NUREG-0565

Generic Evaluation of Small Break Loss-of-Coolant Accident Behavior in Babcock & Wilcox Designed 177-FA Operating Plants

Office of
Nuclear Reactor Regulation

U.S. Nuclear Regulatory
Commission

FIGURE 4-2

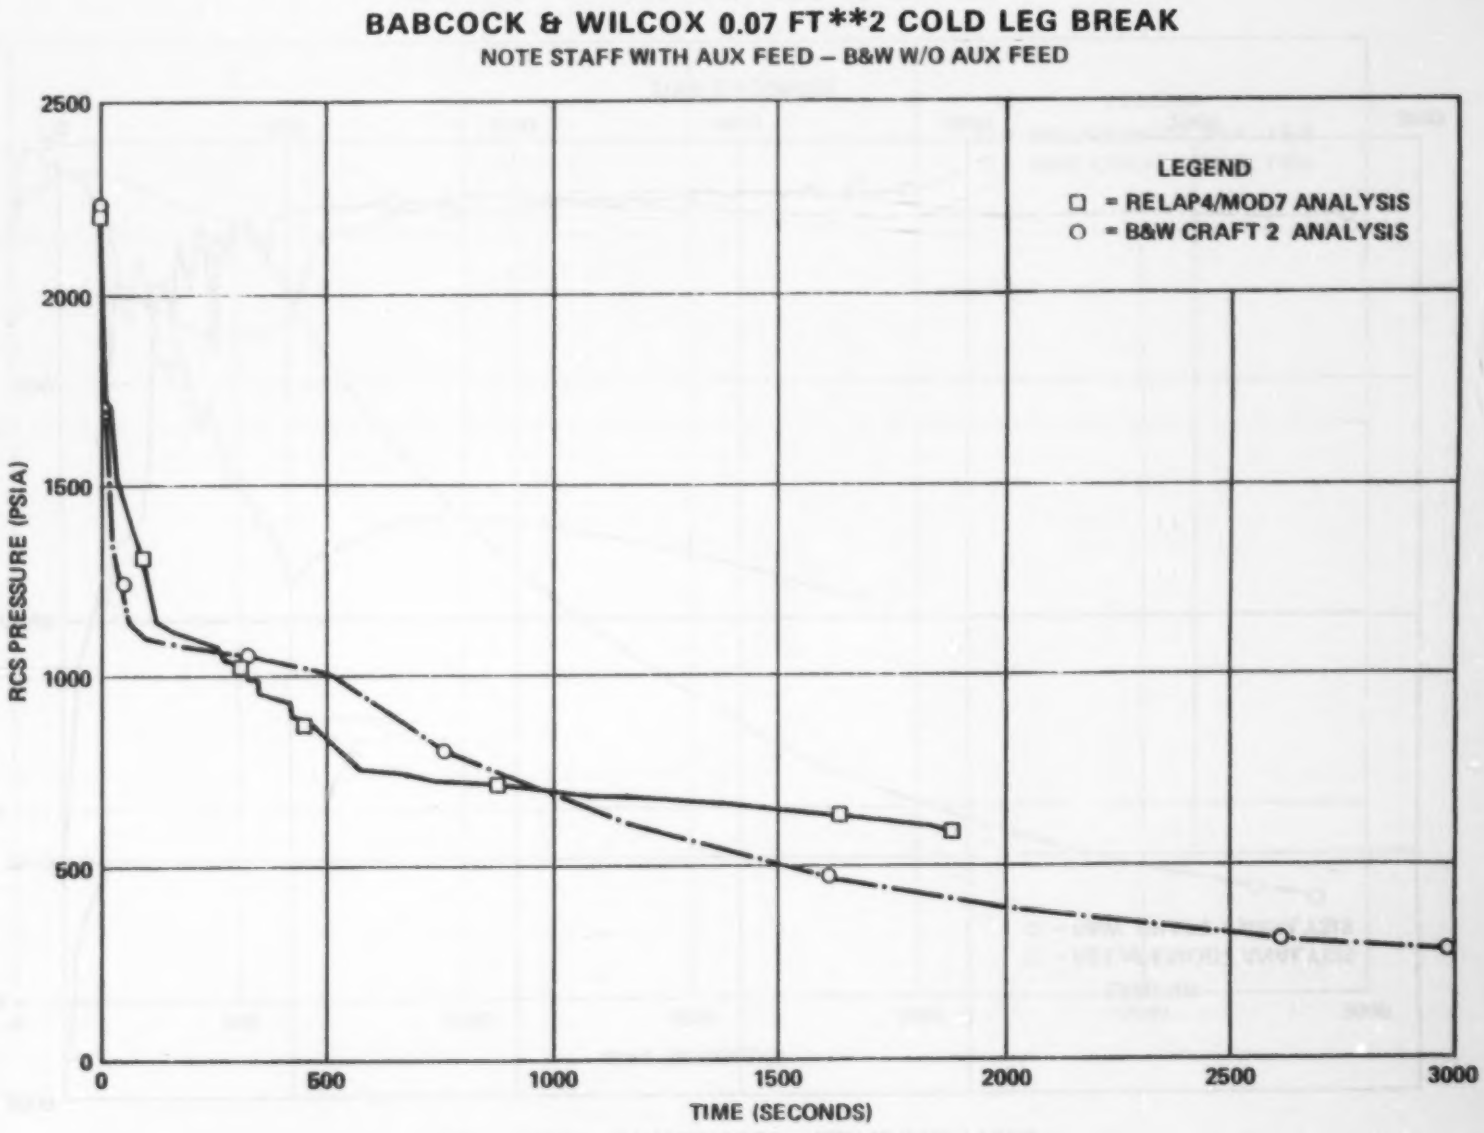
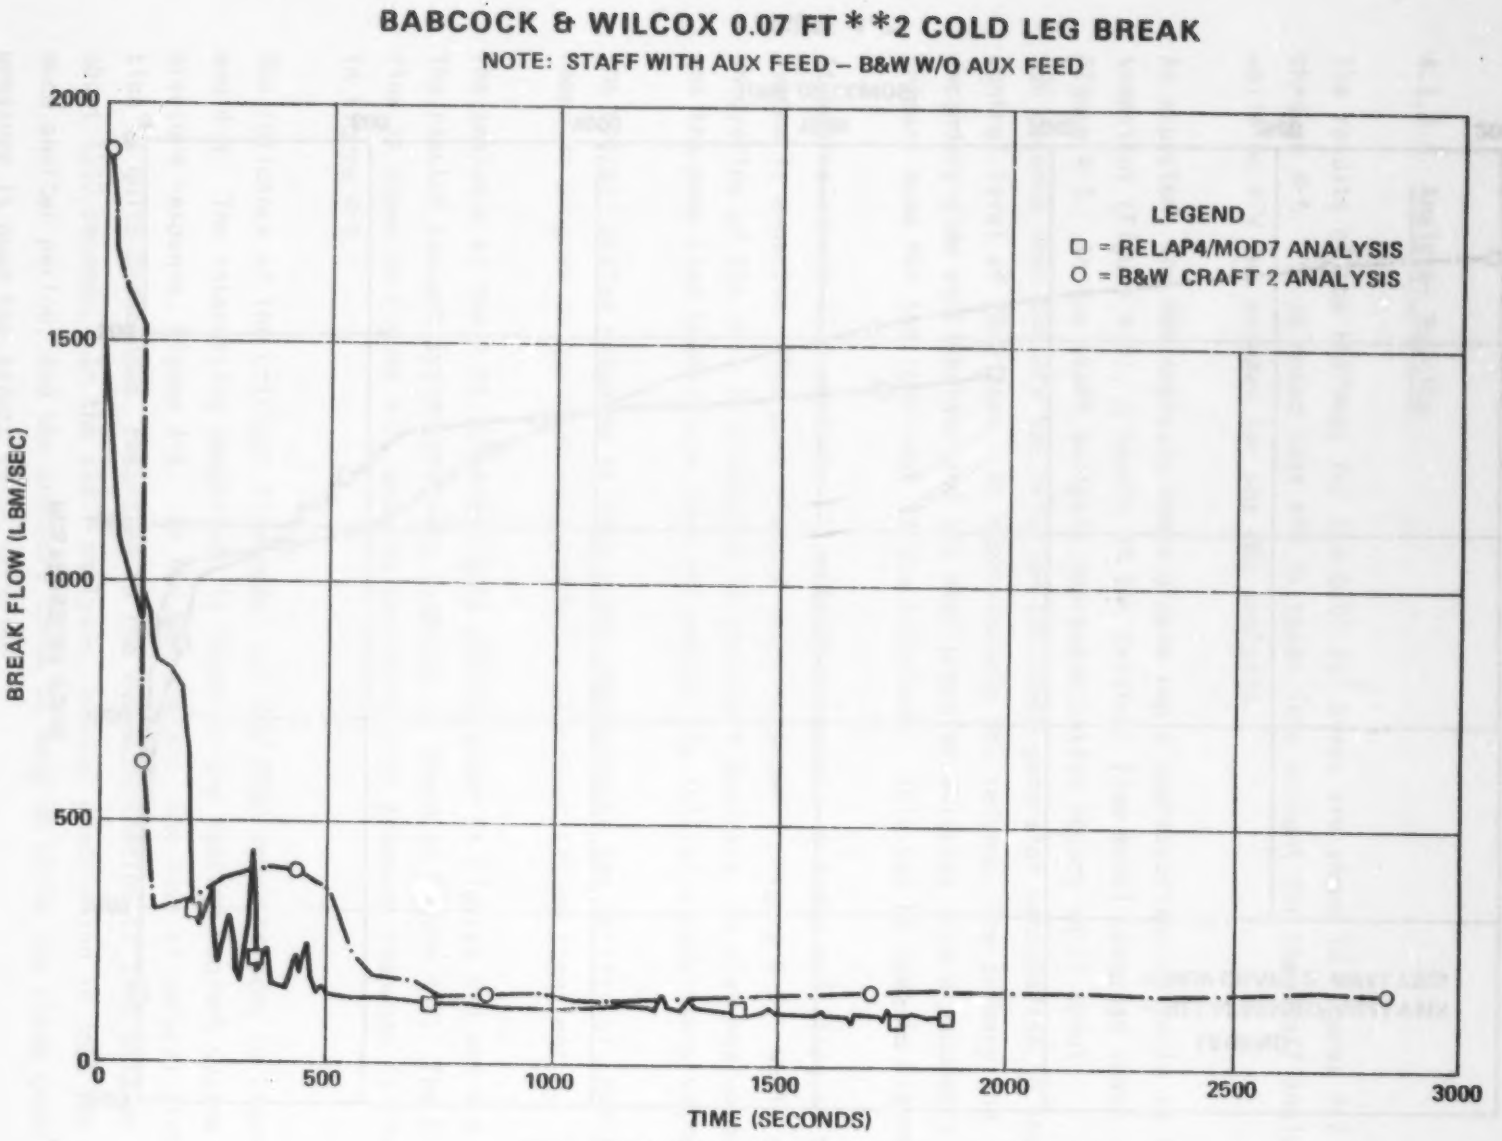
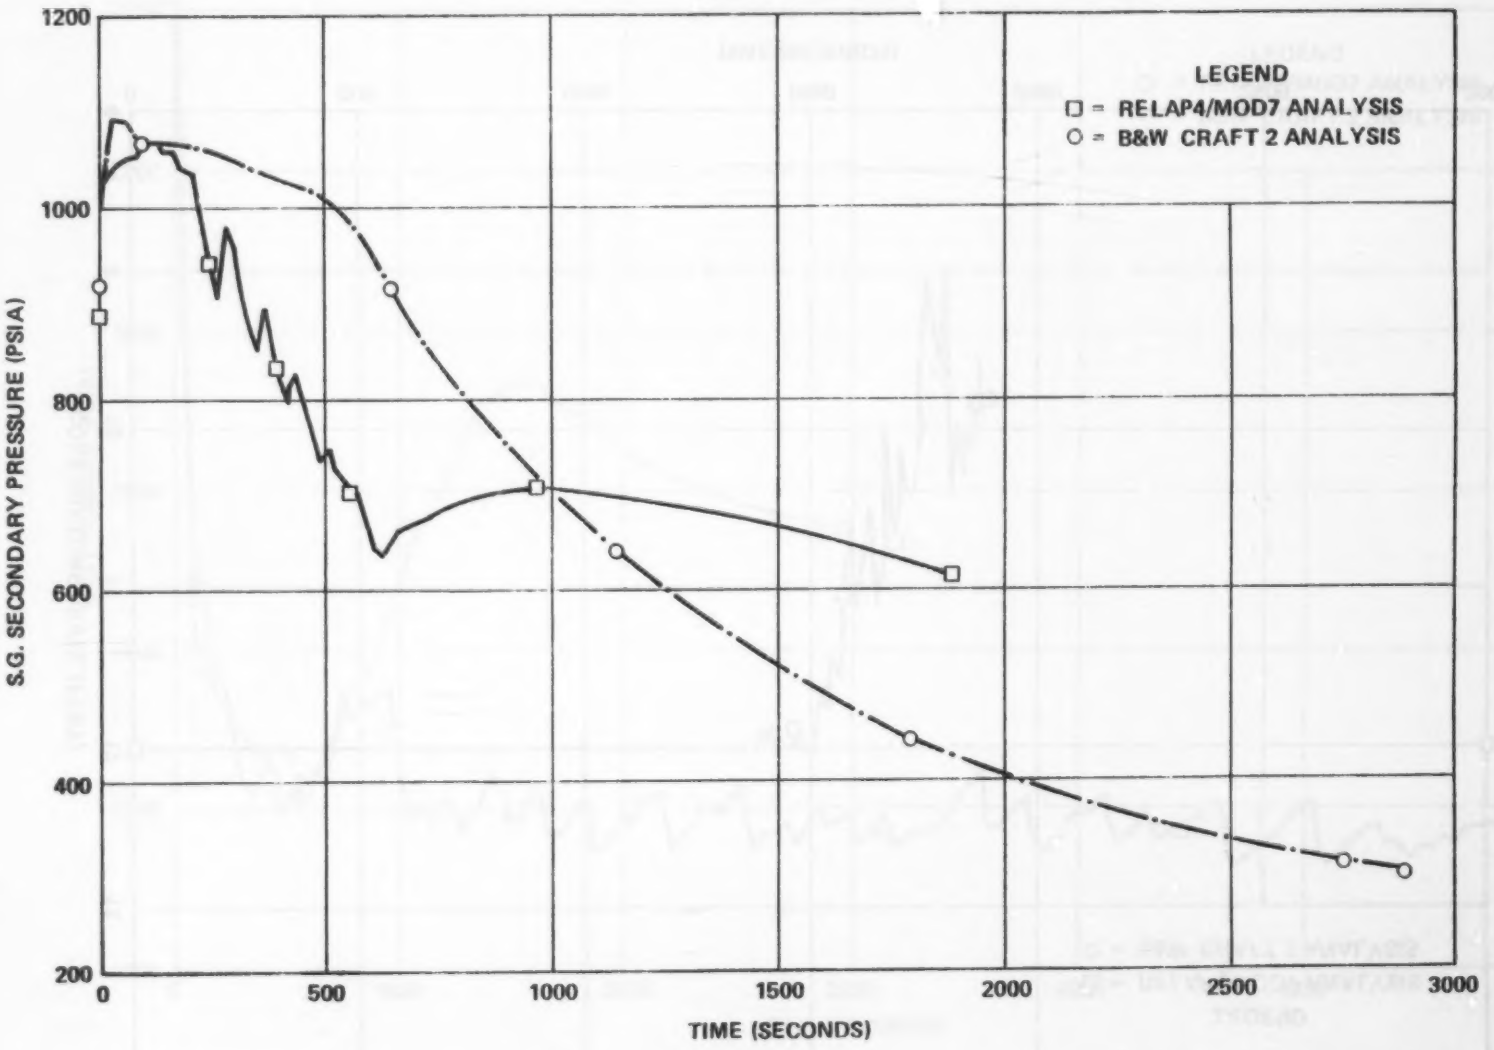
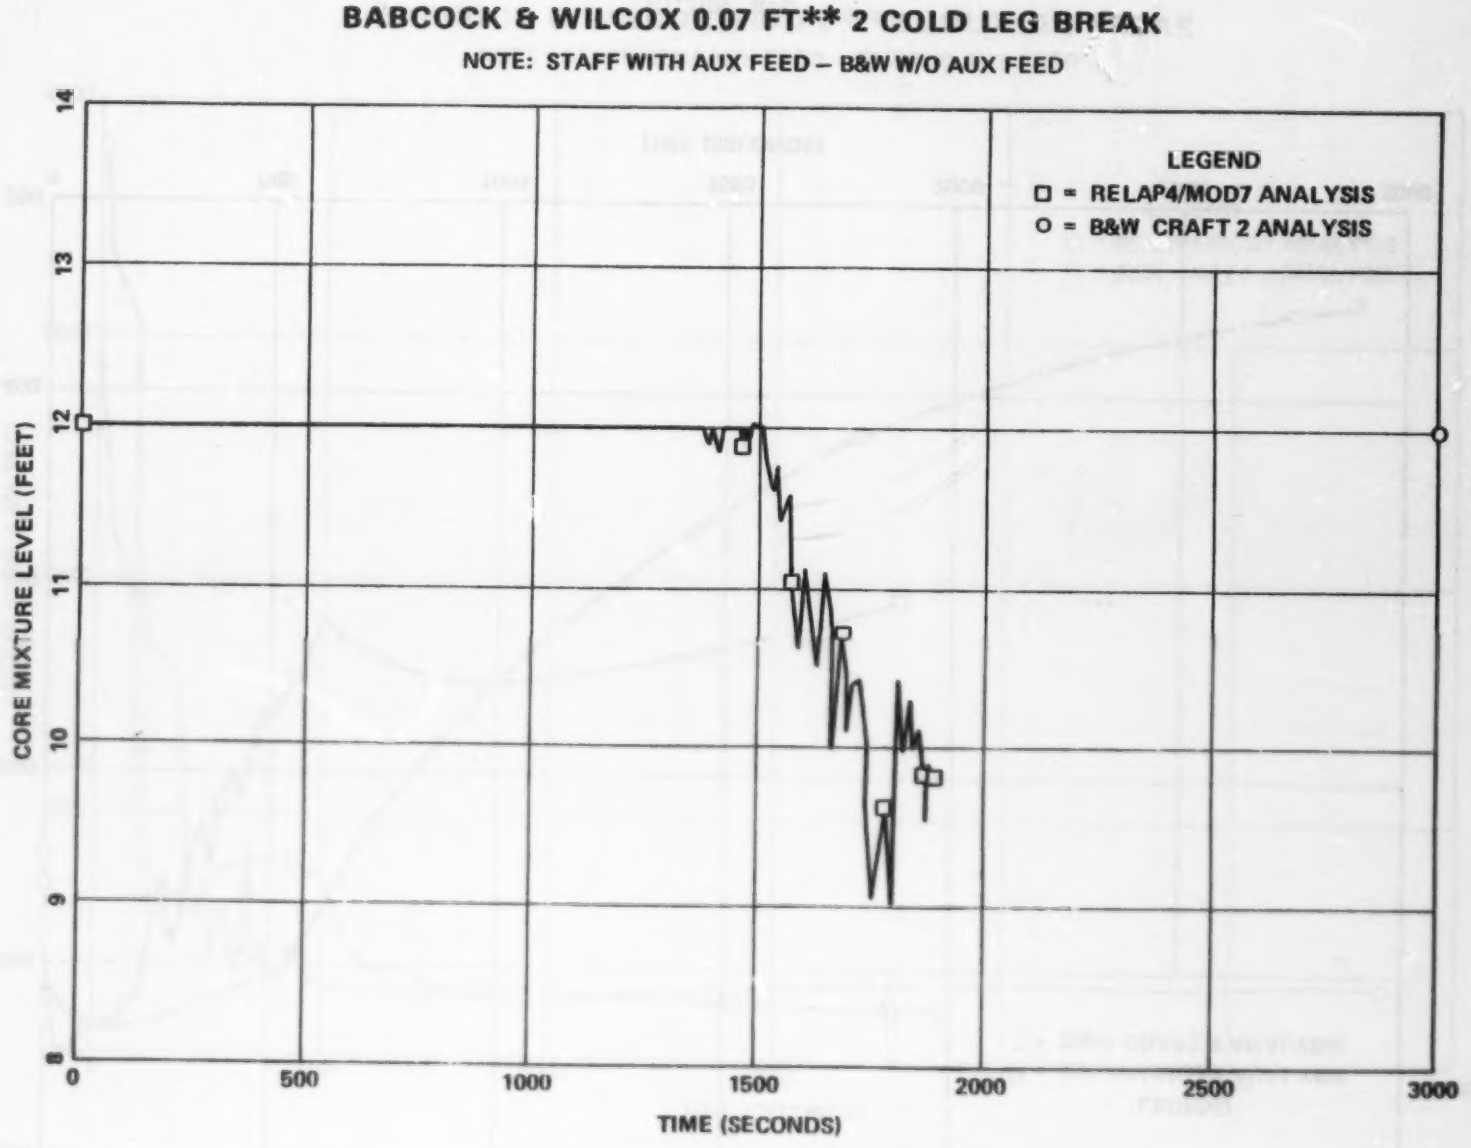
As expected, the B&W analysis shows a more rapid depressurization early in the transient (Figure 4-2), a result of the critical flow model used, as shown in Figure 4-3. In the staff analysis depressurization occurs until about 650 seconds when the AFW has refilled the steam generator secondaries to the control level of 20.2 feet. At approximately 950 seconds, the primary and secondary side equilibriate and the heat transfer switches from a secondary to primary mode for the remainder of the transient. This can be seen in Figure 4-4.

At approximately 1730 seconds, CFT actuation occurs. A rapid refilling of the system is expected. The core mixture level is shown in Figure 4-5. While some uncovering of the core is predicted in the staff analysis, no clad heatup occurs, and the peak clad temperature does not exceed the initial steady-state value.
